APPENDIX D:
INDEPENDENT PEER REVIEW – LANDSCAPE AND VISUAL

JUPITER WIND FARM

***Prepared for
NSW DEPARTMENT OF PLANNING
& ENVIRONMENT***

Review of the Jupiter Wind Farm 54 turbine Proposal

Figure 3.1 The E3 Environmental Management Zone

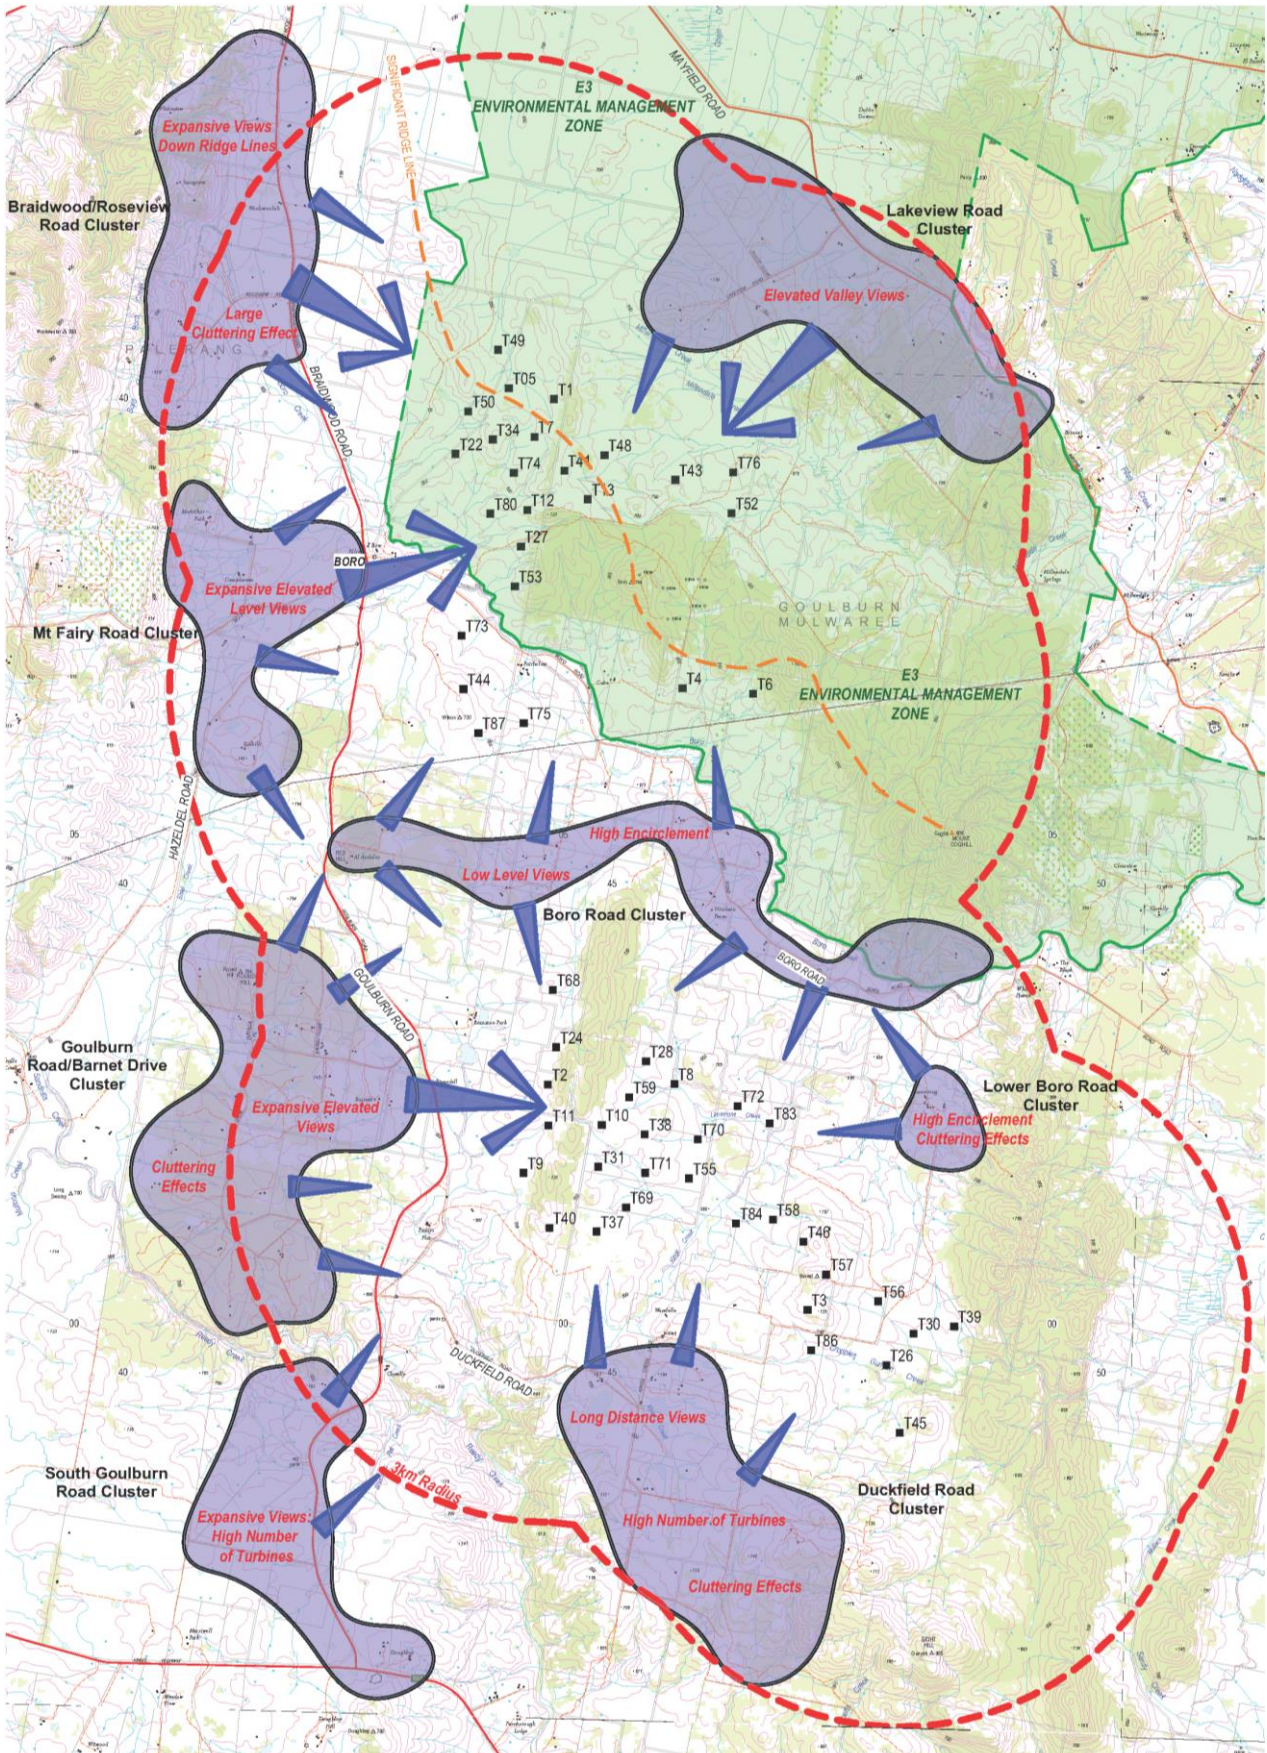
The extent of the E3 zoning relative to the residential assessment clusters is shown on Figure 3.1. Five of the eight residential clusters have views into the E3 – Environmental Management Zone; the Lakeview Road Cluster, the Braidwood/Roseview Road Cluster, the Mt Fairy Road Cluster, the Boro Road Cluster and the Goulburn Road/Barnet Drive Cluster. Most of the proposed Upper Precinct turbines will impact on the E3 zoned landscapes which would be viewed by a high proportion of the 80 residences located within those 5 clusters, most specifically those on elevated sites.

As noted in the UVIA, the location of turbines in the cleared section of the E3 area will impact on the scenic quality of the cleared area. However, when considering the turbines located in the cleared sections of the E3 area their combination with the wider extent of the E3 area, including the adjacent woodlands and remnant vegetation, should be considered. This wider consideration is particularly relevant in the valley south of the Lakeview Road cluster of residences and on along Mayfield Road.

Using this wider level of consideration, it is reasonable to conclude that the aesthetic values to be considered for the E3 zone would be the aesthetic value of the valley, the T05 ridge and surrounding catchment when viewed by users and residents within the E3 zoning and additionally those with views into the E3 zoned areas.

Figure 4.1 Representative Viewpoints

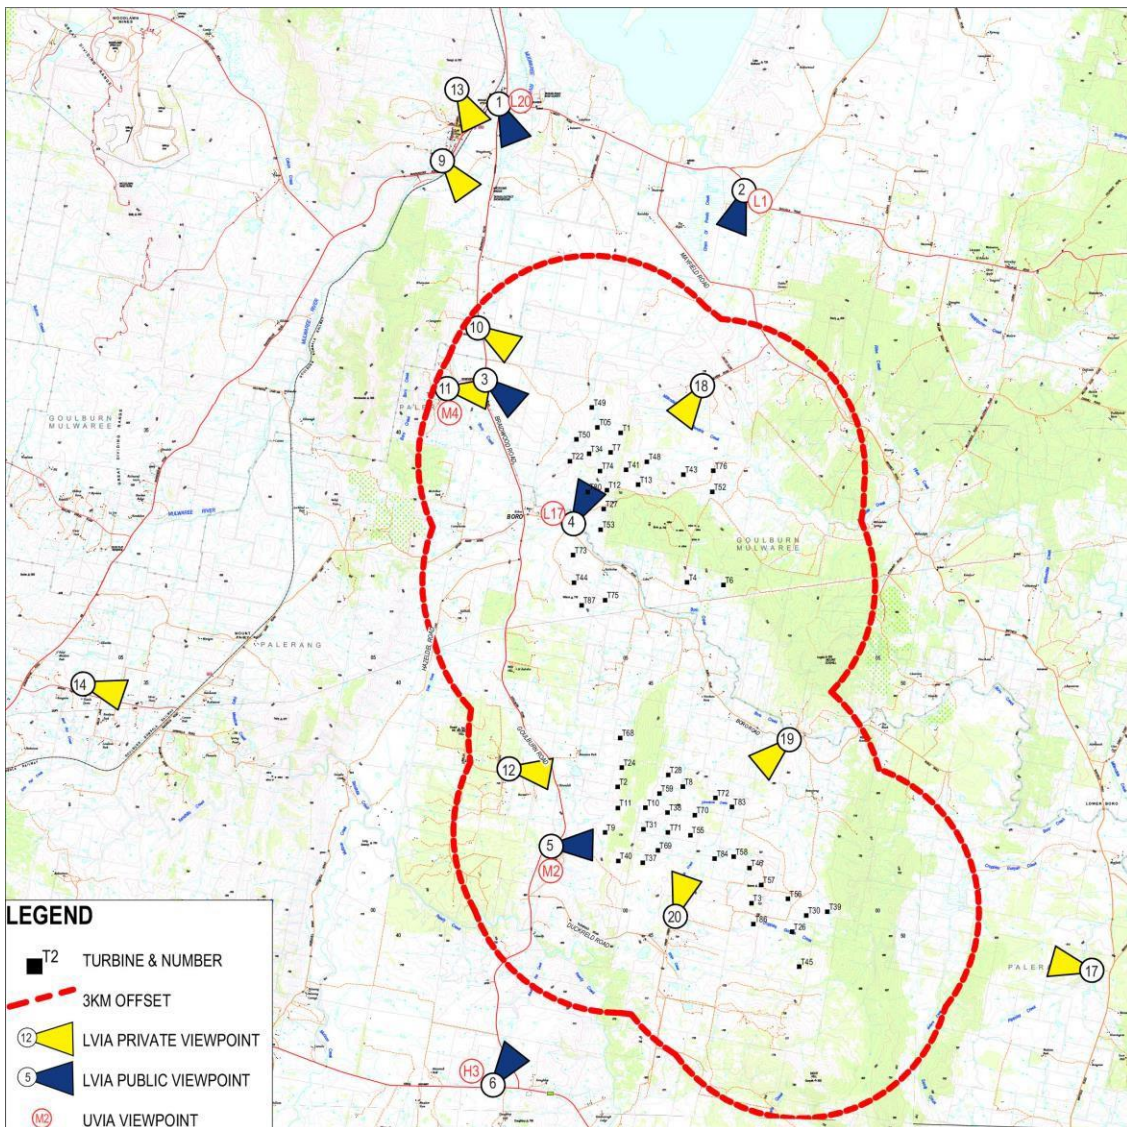
The LVIA Viewpoints appear a representative sample of the variety of public locations and representative of the clusters of residences at varying heights, distances and levels of impact. The selected representative Viewpoints appear to include locations close or adjacent to the likely “worst case scenario” locations. These locations do not exactly match those in the UVIA. Where possible we have identified an adjacent comparable UVIA location and provided the UVIA assessment and location. The following tables are a summary of the impacts at LVIA Public Viewpoints.

For our review of Representative Viewpoints, the Magnitude factor “Distance of View” noted in the LVIA has been adjusted to indicate High impacts out to 3km rather than 2km. Moderate impacts to 10km. Our review is based on existing conditions without modification for any possible mitigation. For our review of the UVIA impacts assessment distances have been adjusted to match the 54 turbines layout and a review of that change of impact compared to the 88 turbine layout has been prepared. LVIA Viewpoints 7,8,15 and 16 have been removed as they are no longer valid in the 54 turbine layout due to the removal of the original Southern Precinct.

Figure 5.1 Residential Clusters

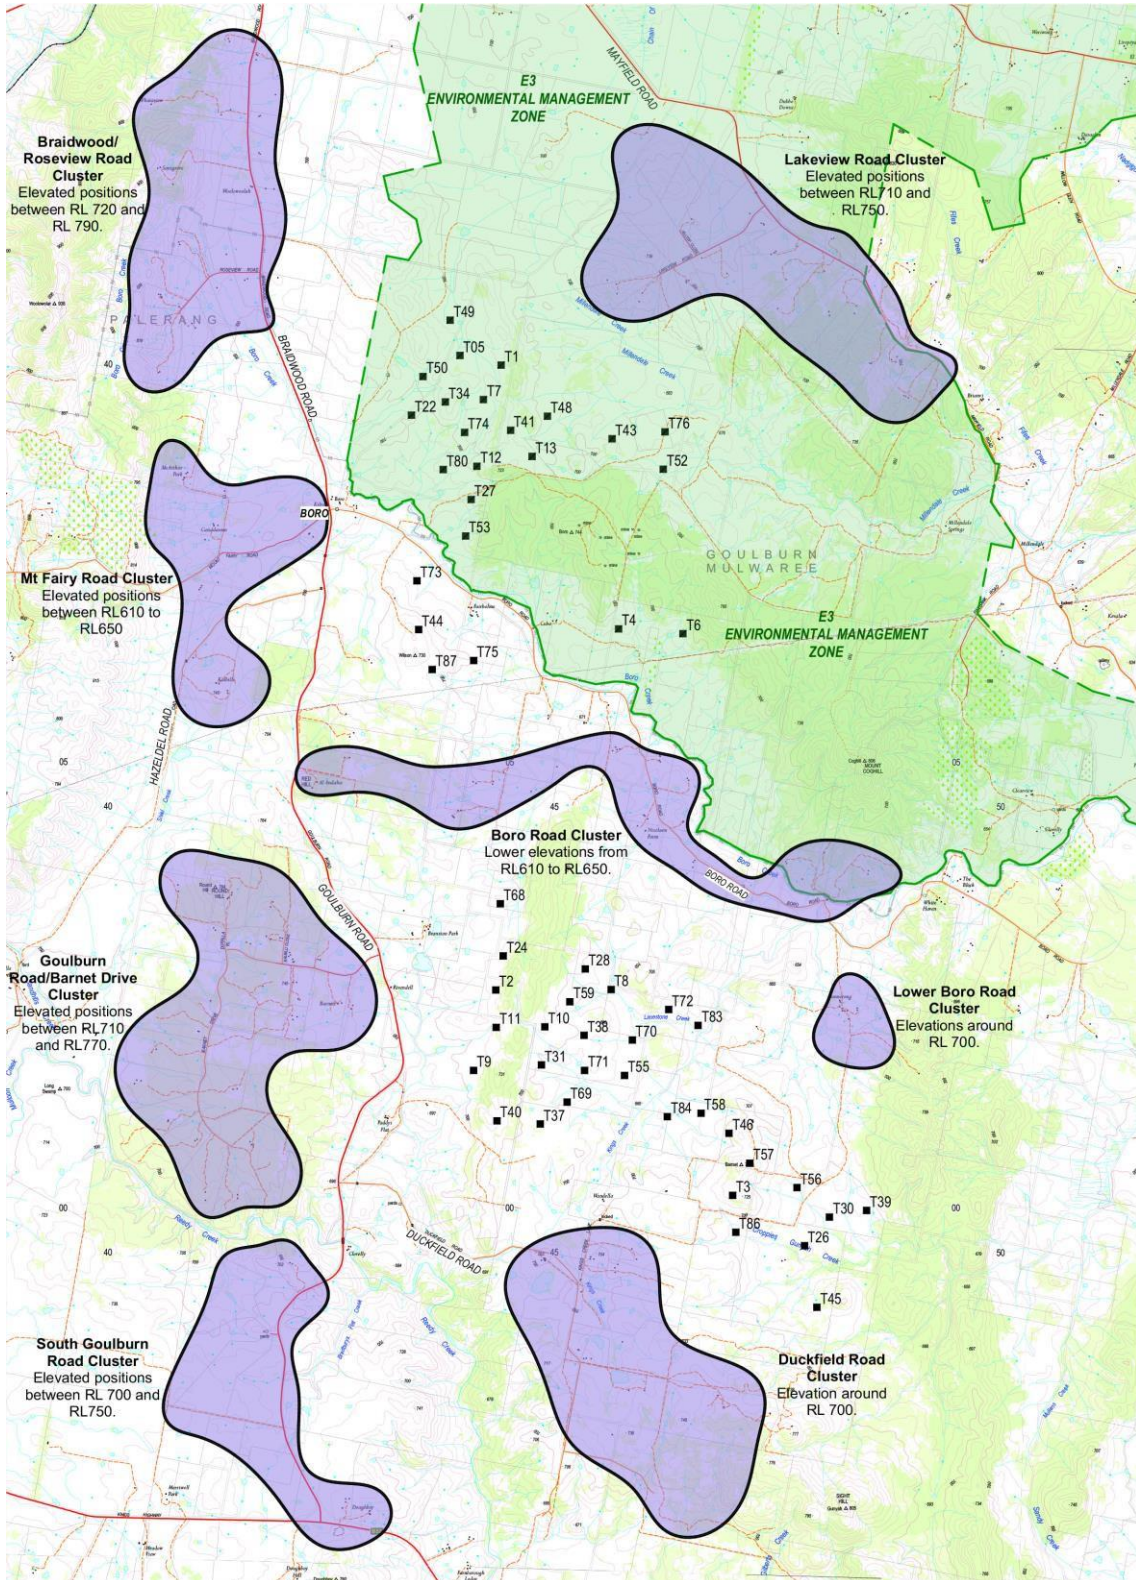
For the purpose of this review we have divided the residential viewing locations into residential clusters as shown below. In this review distances have been adjusted to match the updated 54 turbine layout.

Most of the High ratings fall in the elevated clusters north and west of the Project Area. The removal of turbines in the Lower Precinct has significantly reduced impacts in the South Goulburn Road Cluster.

In the Braidwood/Roseview Road Cluster the proposed reduction in numbers and increased distances from viewpoints in the 54 turbine proposal has reduced some of the impacts however the impacts in the overall landscape are in many cases still significant and several residences are still rated High.

In the Lakeview Road Cluster, the impacts for the most affected residences J003, J76A and J76B remain High.

In the Boro Road Cluster the impacts have not varied significantly. The turbine offset distances at most residences remain less than 2 km. For similar reasons we have assessed no rating changes in the Lower Boro Road Cluster.
